PROPOSED TECHNICAL SPECIFICATION CHANGES

MARKUP OF CURRENT ANO-2 TECHNICAL SPECIFICATIONS

## REFUELING OPERATIONS

### FUEL STORAGE

FIGURE 3.9.2  
MINIMUM BURNUP VS. INITIAL ASSEMBLY AVERAGE U-235 LOADING

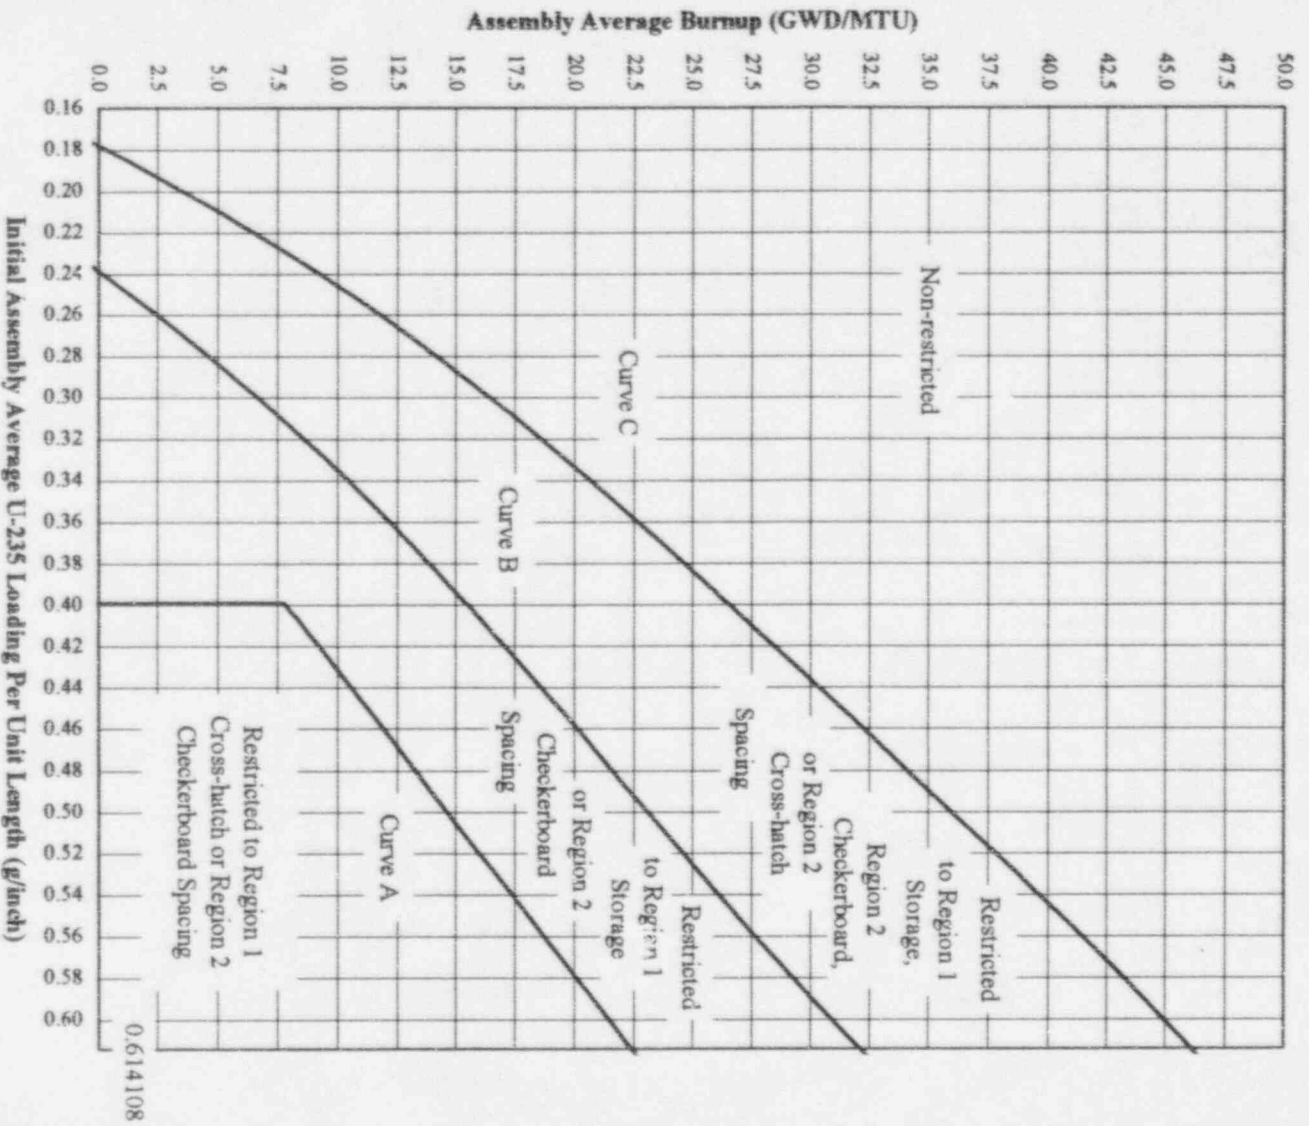
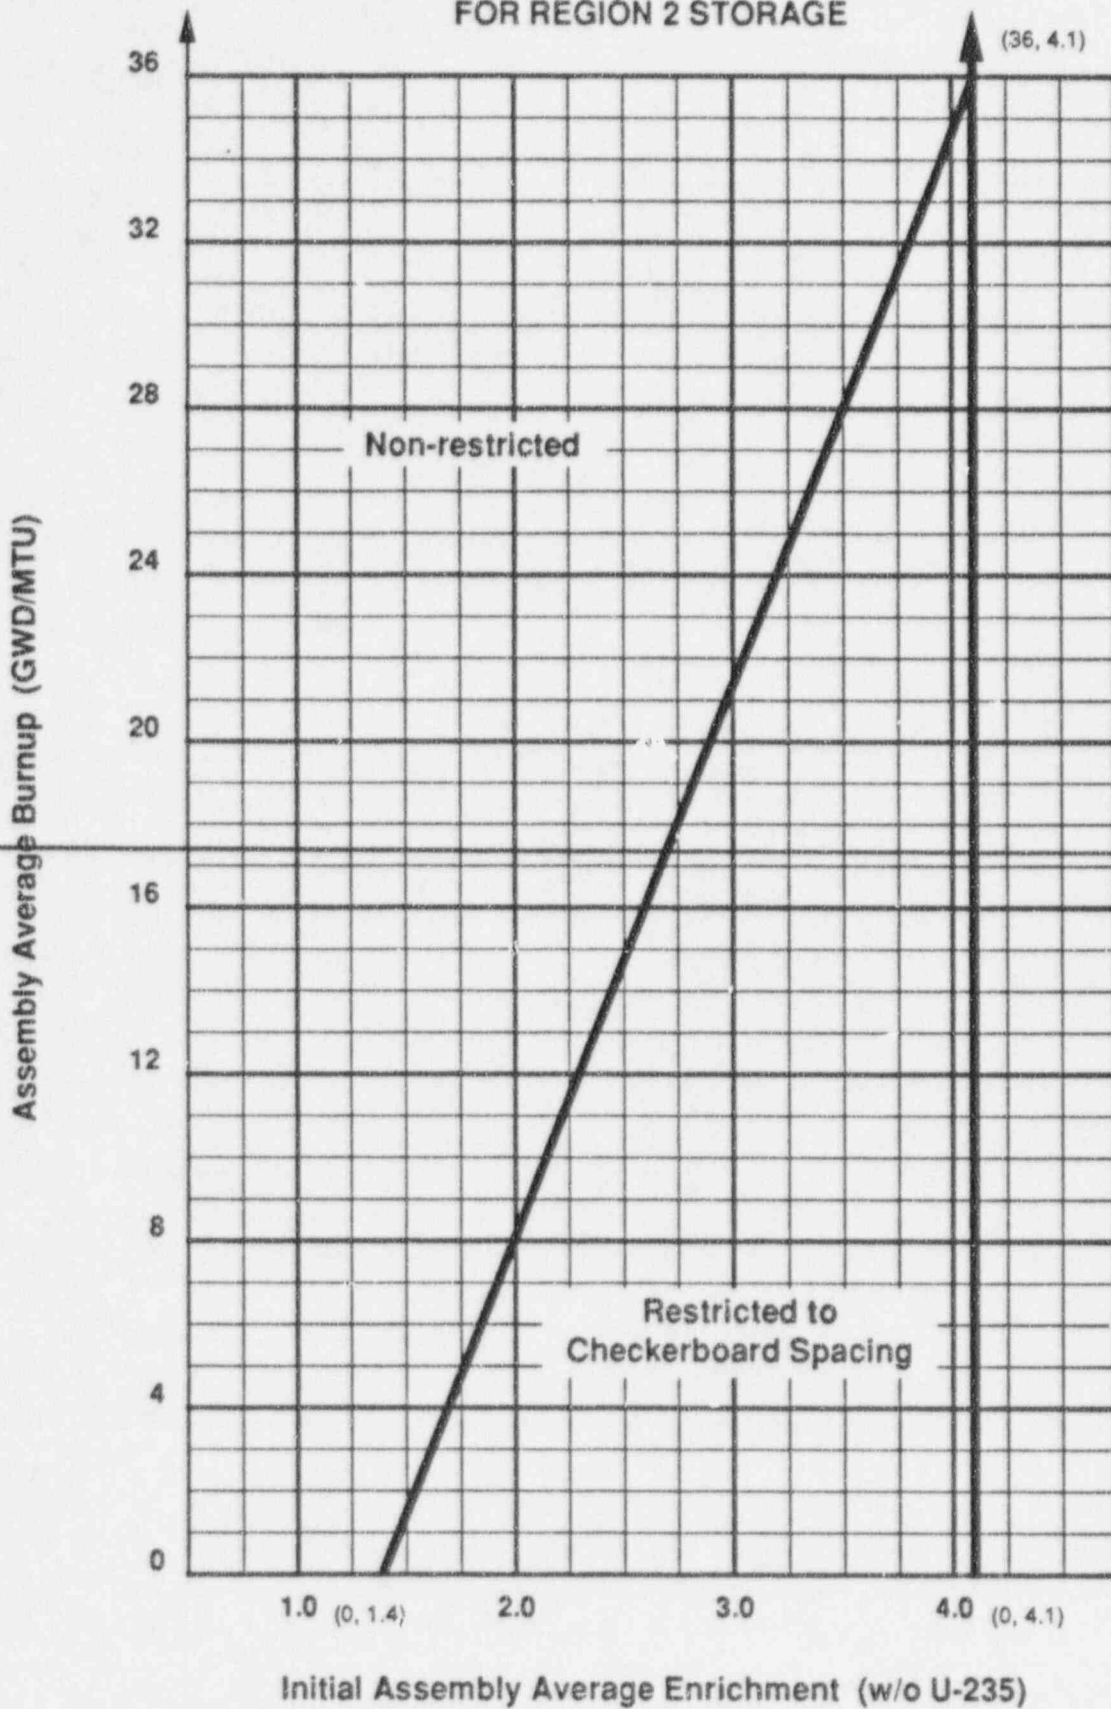
3.9.12.b Storage in Region 1 or Region 2 (as shown on Figure 3.9.1) of the spent fuel pool shall be further restricted by ~~the burnup and enrichment limits specified in Figure 3.9.2.~~ In the event a cross-hatch storage configuration is deemed necessary for a portion of either Region 1 or Region 2, vacant spaces diagonal to the four corners of any fuel assembly or vacant spaces on two opposite faces of any fuel assembly shall be physically blocked before any such fuel assembly may be placed in that region. Also, the Region 1 storage cells adjacent to the Region 2 interface are restricted to fuel assemblies that are outside of the area of the graph enclosed by curve A on Figure 3.9.2. In the event a checkerboard storage configuration is deemed necessary for a portion of Region 2, vacant spaces adjacent to the four faces of any fuel assembly ~~which does not meet the Region 2 burnup criteria (Non-Restricted)~~ shall be physically blocked before any such fuel assembly may be placed in Region 2. ~~This will prevent inadvertent fuel assembly insertion into two adjacent storage locations.~~ The provisions of Specification 3.0.3 are not applicable.

4.9.12.b Verify all fuel assemblies to be placed in ~~Region 2 of the~~ spent fuel pool are within the ~~enrichment and burnup~~ limits of Figure 3.9.2 by checking the assemblies' design and burnup documentation.

3.9.12.b Storage in Region 1 or Region 2 (as shown on Figure 3.9.1) of the spent fuel pool shall be further restricted by the limits specified in Figure 3.9.2. In the event a cross-hatch storage configuration is deemed necessary for a portion of either Region 1 or Region 2, vacant spaces diagonal to the four corners of any fuel assembly or vacant spaces on two opposite faces of any fuel assembly shall be physically blocked before any such fuel assembly may be placed in that region. Also, the Region 1 storage cells adjacent to the Region 2 interface are restricted to fuel assemblies that are outside the area of the graph enclosed by Curve A on Figure 3.9.2. In the event a checkerboard storage configuration is deemed necessary for a portion of Region 2, vacant spaces adjacent to the four faces of any fuel assembly shall be physically blocked before any such fuel assembly may be placed in Region 2. The provisions of Specification 3.0.3 are not applicable.

4.9.12.b Verify all fuel assemblies to be placed in the spent fuel pool are within the limits of Figure 3.9.2 by checking the assemblies' design and burnup documentation.

Curve A =  $68.008x - 19.366$  when  $x > 0.399181$   
 Curve B =  $239.01x^3 - 347.75x^2 + 243.18x - 41.452$   
 Curve C =  $-714.35x^4 + 1335.80x^3 - 946.44x^2 + 394.52x - 47.040$
